RE: North Rose Wolcott CSD 2017 Capital Improvement Project
Leavenworth Middle School –Recommendation for CO GT-069 Removal of 1st floor topping

Re: North Rose-Wolcott Central School District
6168 West Port Bay Road, Wolcott, NY 14590
2017 Capital Improvement Project
North Rose-Wolcott Middle School Floor
Leveling Change Order (GT-69)
SED# 65-15-01-06-0-001-016
SWBR Project No. 17225.00

CHANGE ORDER NUMBER: GT-069
INITIATION DATE: October 24, 2019

Regarding: RFP GT-108 1st floor topping removal (RFP)

AM- 102

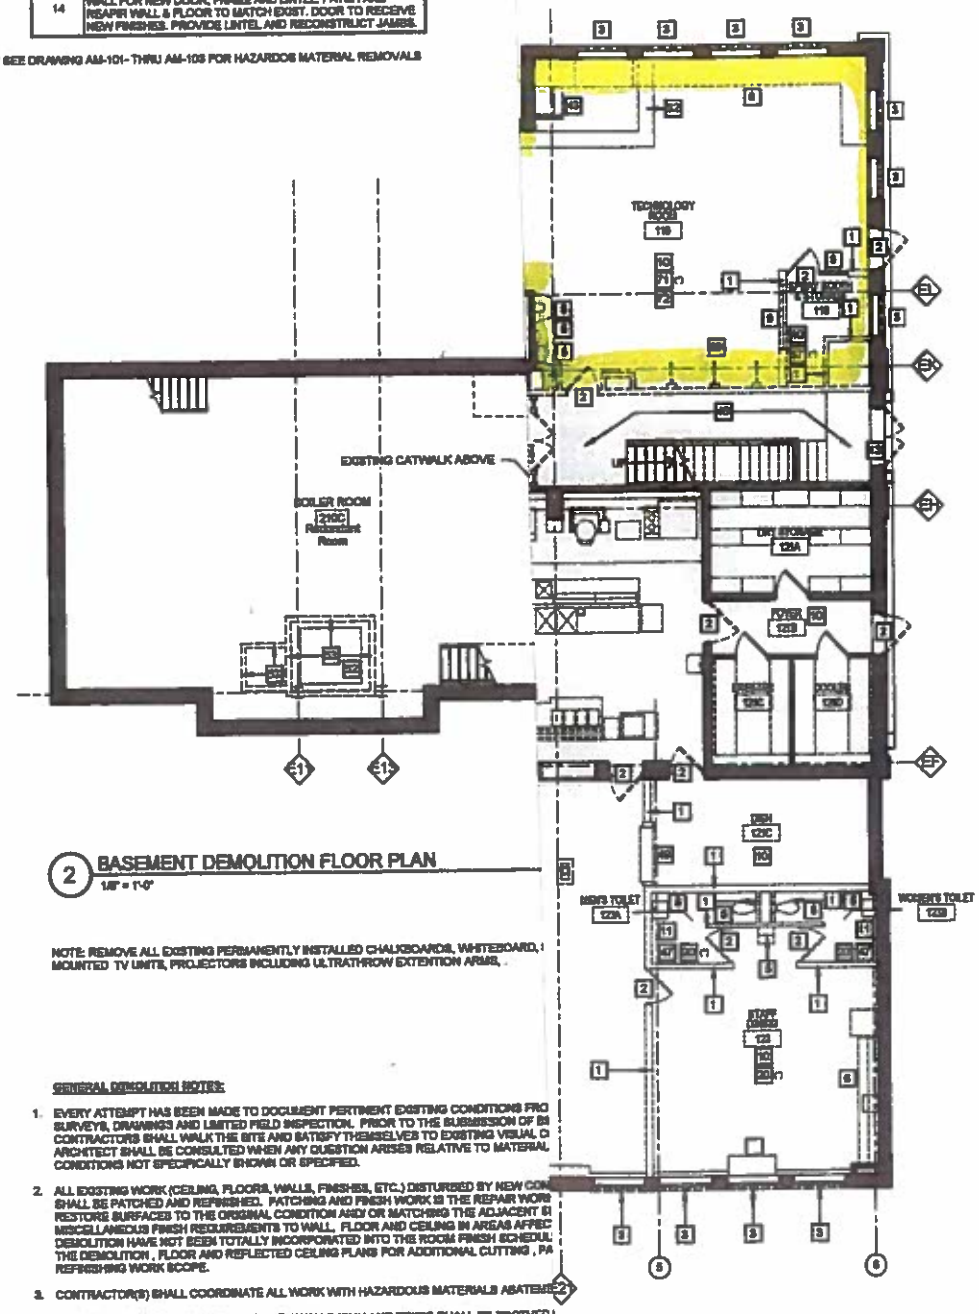
During the North Rose Wolcott CSD, Leavenworth Middle School renovation; it was found that there was existing underlayment floor leveling materials on the 1st floor that had been installed at different times throughout the years, and that those generations of floor leveling materials had lost their bond with the existing concrete deck beneath. Due to this material being un-bonded, it then needed to be removed.

RFP GT-108 Removal of 1st floor topping at the Middle School as indicated on drawing (AM-102).....$36,705.00
The consideration stipulated for performance of this change represents total and complete compensation for such performance including impacts, if any, on the unchanged work.

Remove floor topping on 1st floor as indicated on attached drawing. (AM-102)

- **Remove and dispose of 504 Sq Feet of 2" floor topping**
- **Remove and dispose of 2542 Sq Feet of ½ " floor topping**
- **Cut , remove and dispose of 140 Sq Feet of 5" Concrete**
